Summary of PIIA Bi-Level Final Review Requested Changes
(consecutive numbers starting at 1)

PRIIA 305
Recommendation
Submittal Number 30

P1 – P2 Force versus Time

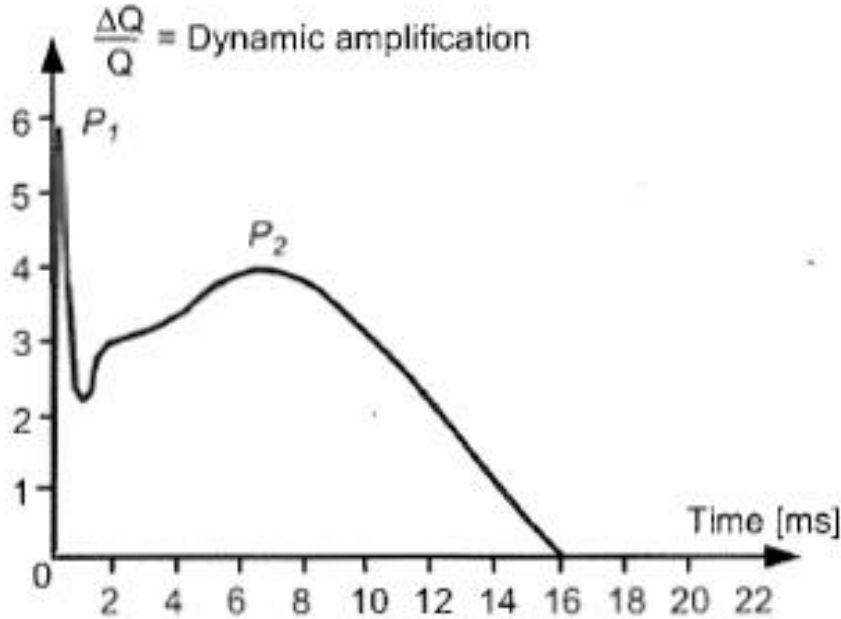
<p>5.4.3 (4th paragraph)</p>	<p>P2 forces shall not exceed 68000 lbs with a 1⁰ dip angle using the Esveld equation.?</p>	<ul style="list-style-type: none"> • Please add the equation and description of variables in the specification. • Rail parameters (damping and stiffness) need to be defined by the transit authority. <p>We believe These levels were "Theoretically Generated" by a class 55 Locomotive at 100 MPH with an axle loading of 86 KN.</p> <p>The proposed vehicle speed and axle loadings are higher.</p>	<p>Urgent</p>	<p>This should be a design guideline or recommended practice instead of an absolute requirement.</p>
------------------------------	--	---	---------------	--

Revision: add the following to Section 5.4.3, 4th paragraph, 1st sentence (After the text, “Vertical P2 forces shall not exceed 68,000 lbs with a 1° dip angle using the Esveld equation.”)

$$P_2 = P_0 + 2\alpha v \sqrt{\frac{m_u}{m_u + m_{T2}}} \left[1 - \frac{c_T \pi}{\sqrt{k_{T2}(m_u + m_{T2})}} \right] \sqrt{k_{T2} m_u}$$

The parameters in the P₂ force calculation are:

- P₀ is the nominal static vertical wheel load (pounds)
- 2α is the total dip angle at a joint, weld dip or other rail discontinuity (radians)
- v is the speed (inches/sec)
- m_u is the unsprung mass of the wheelset (pounds-sec²/inch)
- m_{T2} is the equivalent track mass (pounds-sec²/inch)
- C_T is the equivalent track damping (pounds-sec/inch)
- K_{T2} is the vertical track stiffness (pounds/inch)

The assumed values of selected parameters are:

- 2α = 0.017 rad, (1 degree) with half of this (α) on either side of the dip.
- m_{T2} = 1.1335 pounds-sec²/inch, for nominally stiff concrete tie track
- C_T = 671 pounds-sec/inch, from literature for nominal track conditions

$K_{T2} = 330,000$ pounds/inch, for nominally stiff concrete tie track which corresponds to a track modulus of 4000 pounds/in/in (assuming a track deflection of 0.10 inches under a wheel load of 33,000 pounds)
